DOE/ID-10984
Revision 0
February 2003

U.S. Department of Energy
Idaho Operations Office

INEEL CERCLA Disposal Facility Complex Remedial Action Work Plan

Figure 1-2. Location of the ICDF Complex components and proximity to the INTEC.

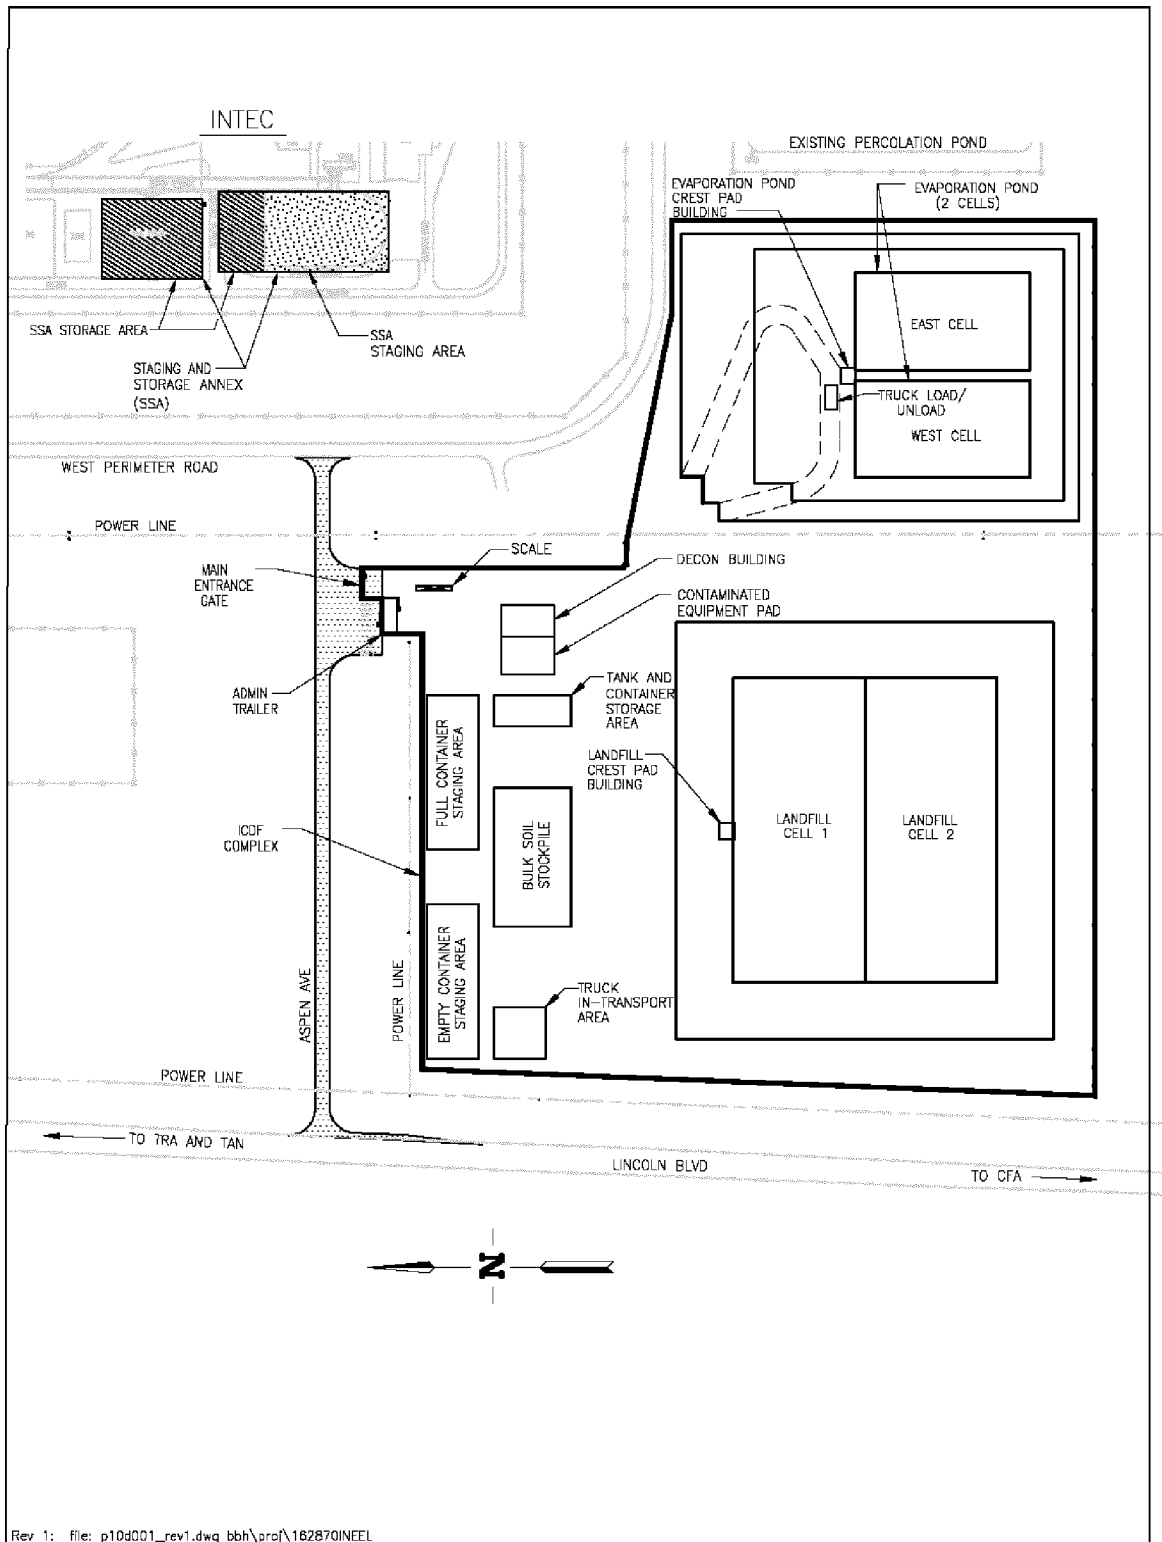
DOCUMENT TITLE: Previous Responses				
Item	Section/ Figure/ Appendix	Page	Comment	Resolution
1.	Draft RA Work Plan Comment #7		Figure 1-2 has not been corrected. Elsewhere in the submittal, e.g., Figure 5-3 in the Operations and Maintenance Plan, this figure has been corrected to read <i>"truck in-transport area."</i> Please correct Figure 1-2 for consistency with the text and other plan documents.	Comment will be incorporated.

Figure N-1. ICDF Complex critical path schedule.

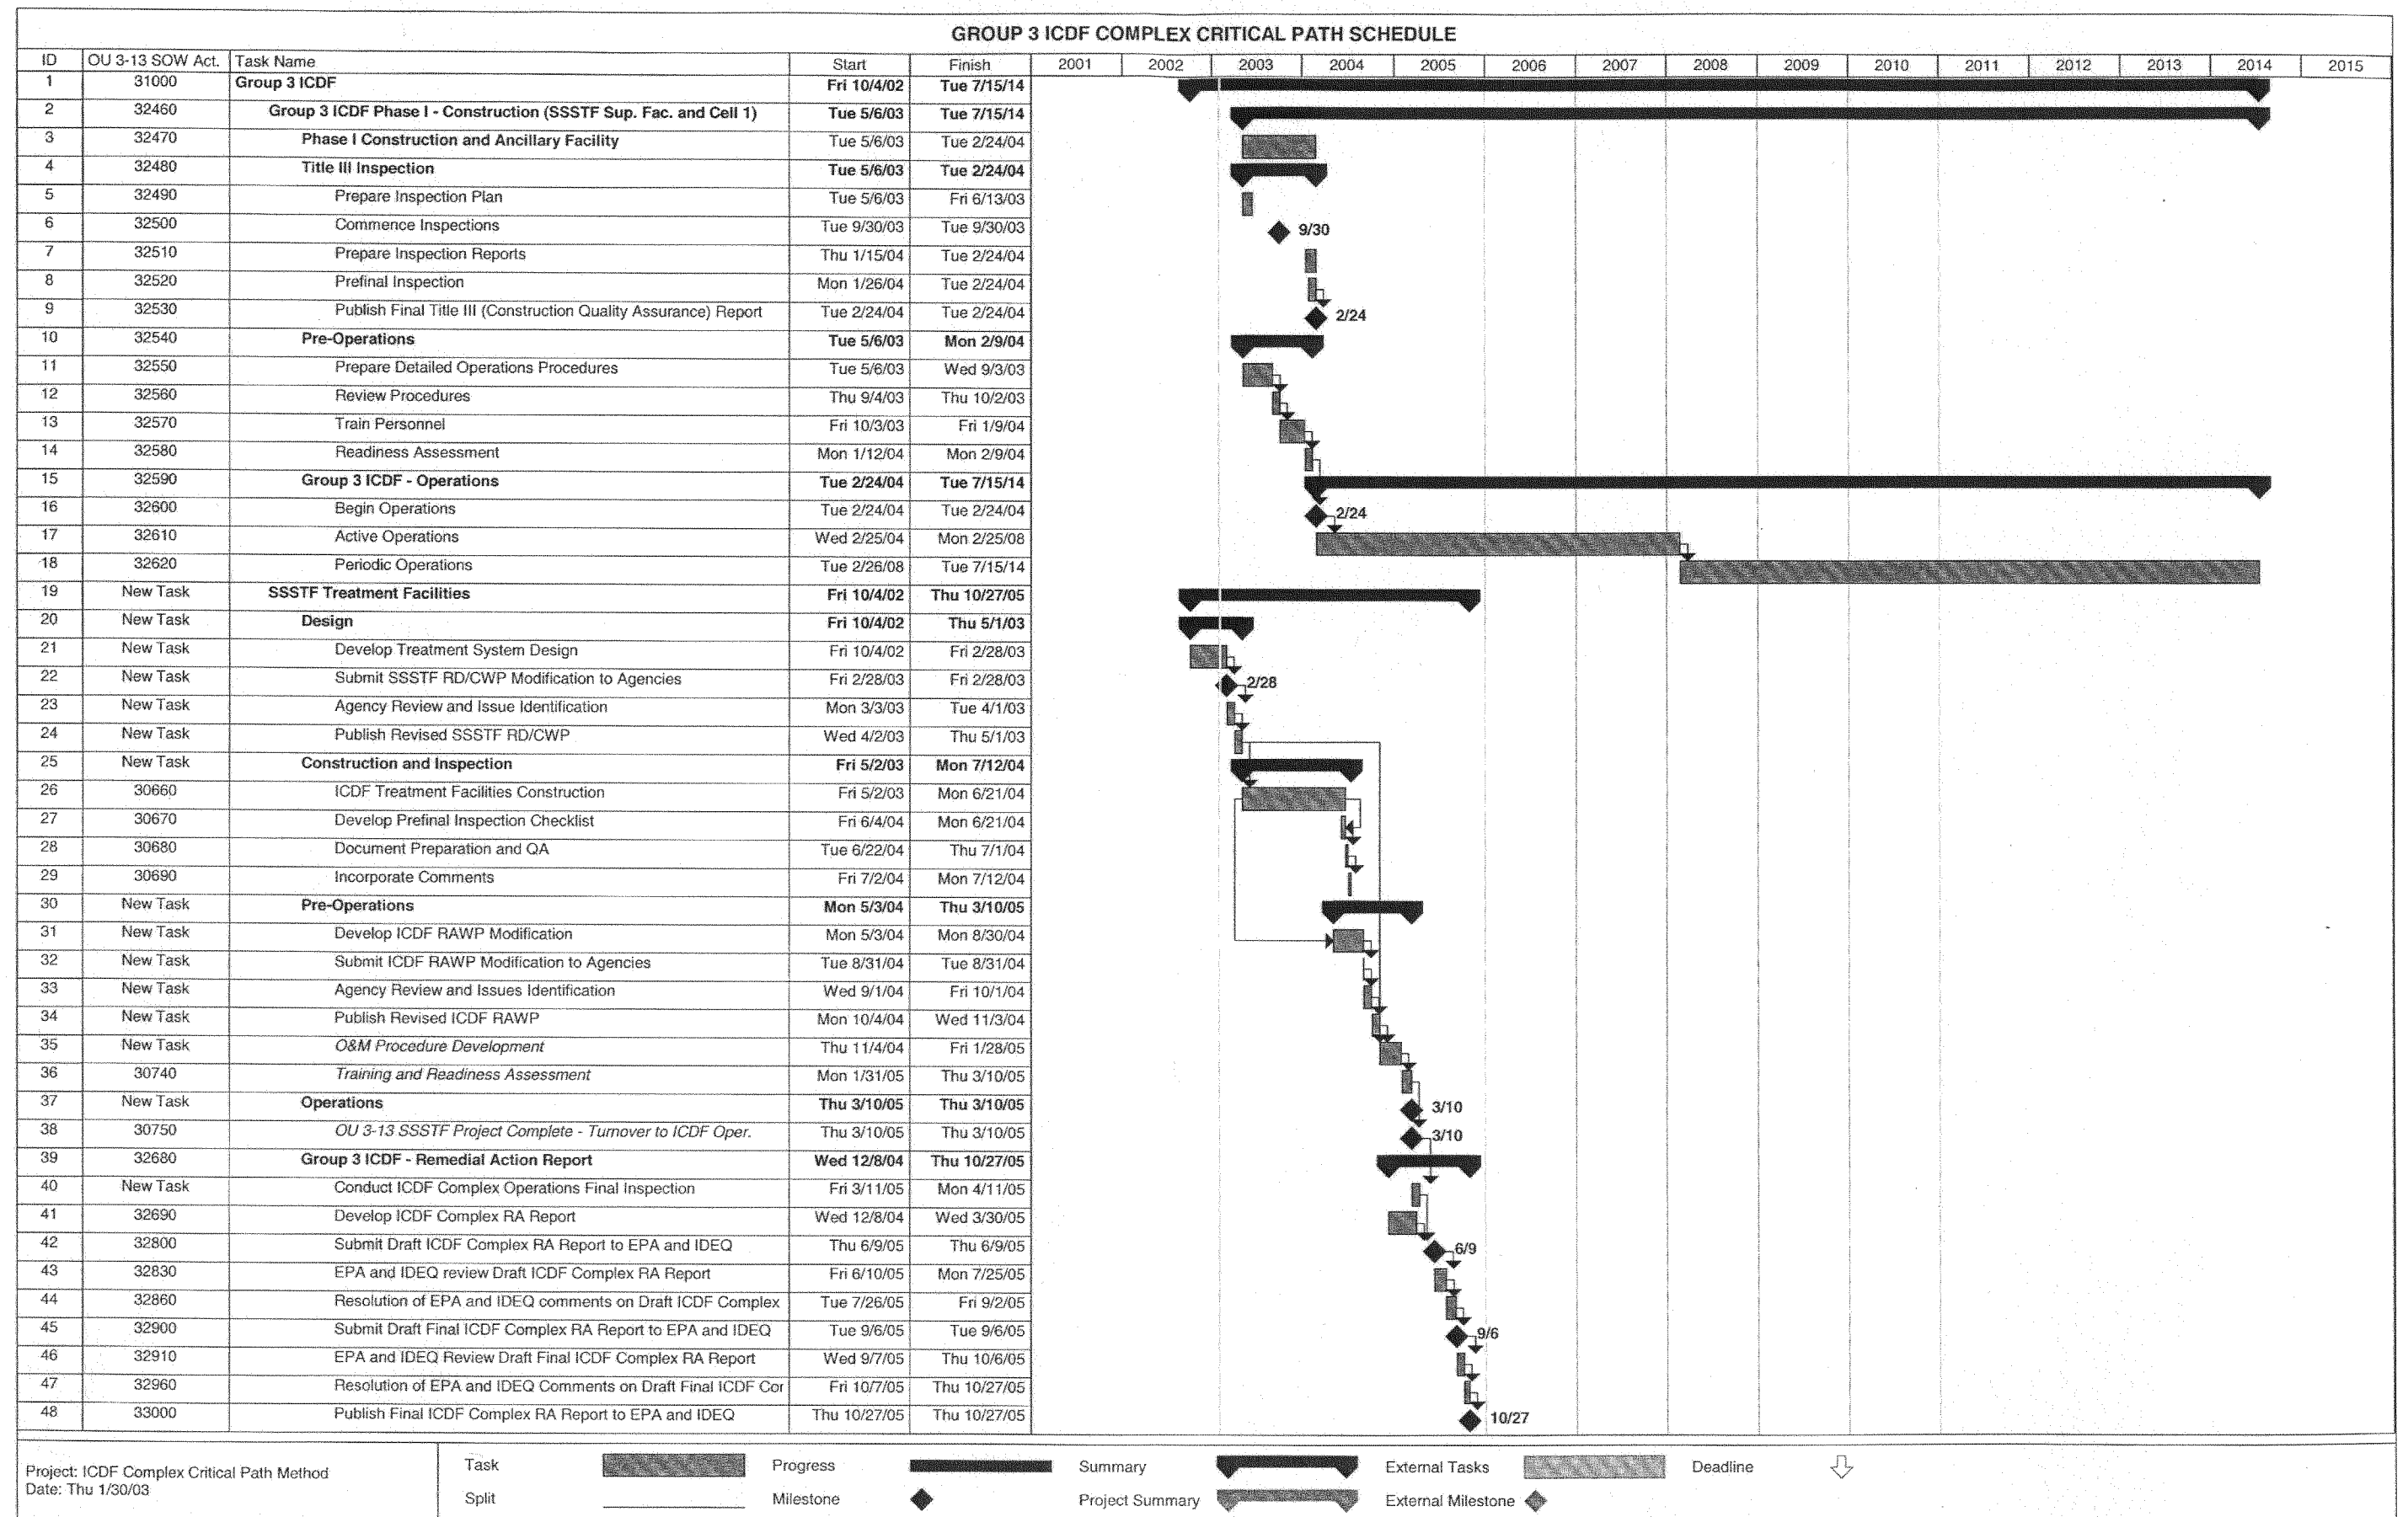
DOCUMENT TITLE: Schedule (Appendix N)				
Item	Section/ Figure/ Appendix	Page	Comment	Resolution
93.	Schedule Fig N-1	N-5	** The project schedule should consist of a critical path schedule for meeting enforceable deadlines and a working schedule. The CPM with enforceable deadlines is required and is not provided.	Two project schedules will be provided in the final RAWP—an enforceable and a working schedule. Both schedules will be developed using critical path methodology.
